This page lists the know errors on the gm5x5x5 PCBs. There are no known issues with the bulk order run (white pcbs), the following information is valid **only** for the prototype run (green pcbs).

## **Bulk Order #1 (white pcb, rev 1.0)**

## **Prototype Run**

### **#1 MIDI IO pins**

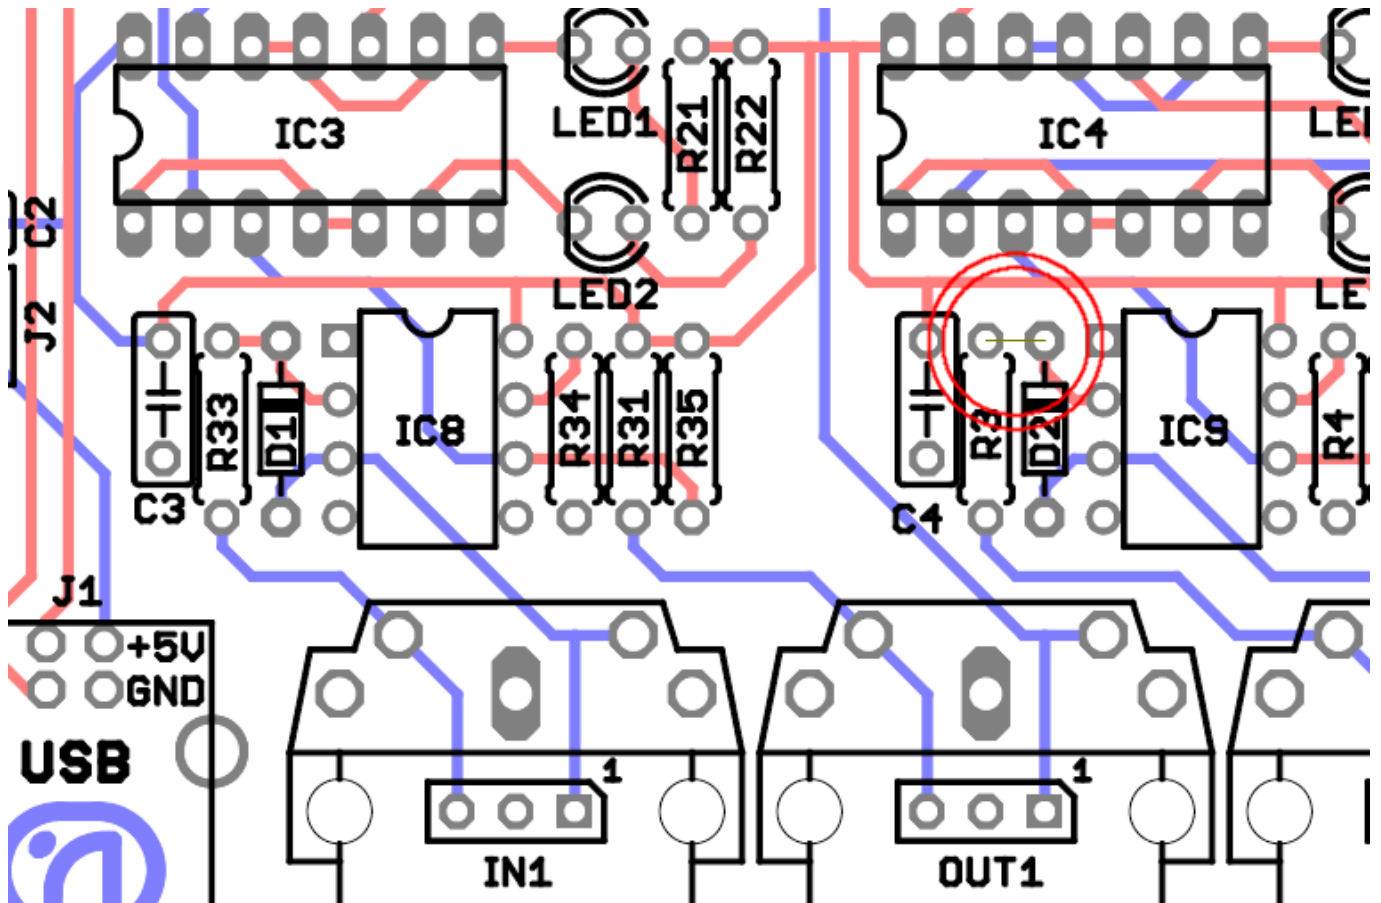
**Problem:** The MIDI IO pins of the midi sockets (Pin 4 + 5) are switched.

**Solution:** Either (1) use the pin-headers if you use sockets that are not mounted on the pcb or (2) break the traces to pins 4 + 5 of the sockets and solder wires to them or (3) solder the midi sockets on the other side of the pcb.
